NRDC Comments on ENERGY STAR Lamps Version 1.0 Draft 4 Specification

Noah Horowitz
Senior Scientist

Natural Resources Defense Council (NRDC)

May 17, 2013

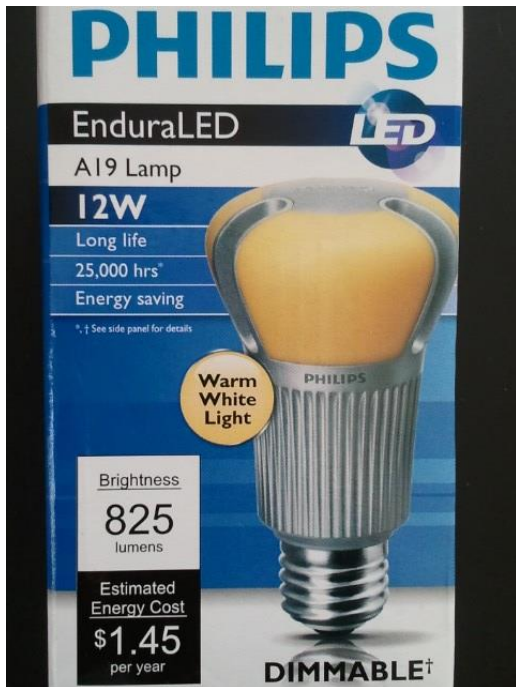
Below we provide a real example of what a consumer might experience if ENERGY STAR's proposal goes through. In the photos below we show the front and side panel of the Philips Endura¹ LED lamp. Nothing on the front panel indicates the lamp should not be used in enclosed fixtures. The side panel contains multiple claims and warnings and one would need to look very carefully to find the warning "Not for use in totally enclosed luminaires". In fact many consumers may not even look at this side panel when shopping or be familiar with the term luminaire. The mere presence of this type of claim is unlikely to prevent the typical consumer from placing LED lamps into a enclosed fixture that are not designed to be placed there.

NRDC therefore recommends ENERGY STAR reinstate its requirement for LED lamps to be tested in elevated temperature environment and to meet the corresponding lumen maintenance and lamp failure/lifetime requirements.
